Permitting decisions

Variation

We have decided to grant the variation for Oakthorpe Dairy operated by Arla Foods Limited. The variation number is EPR/BN0465IG/V004.

EPR/BN0465IG/V004 Date issued: 14/03/2019

Figure 1: Treatment of Milk - Process Flow Diagram

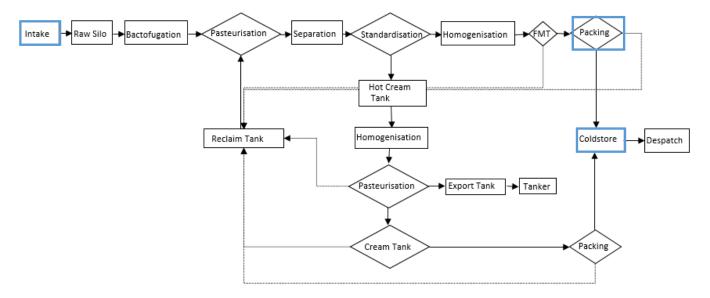
- Increase in production volume to a maximum of 550 million litres of raw milk from the currently permitted volume of 380 million litres. The theoretical maximum capacity of the site will remain unchanged at 620 million litres.
- Phased replacement and upgrading of onsite refrigeration equipment.
- Installation of a new high-speed filling line fed from existing processing equipment
- Alteration of the internal space currently allocated to the TET (Tetratainers) returns area and the 'medium care' area to accommodate the new filling line and maximise the utilisation of the existing space.
- Addition of a further tanker import bay.

The below schematic shows the process flow of the treatment of milk at the installation. The changes relating to this variation have been highlighted.
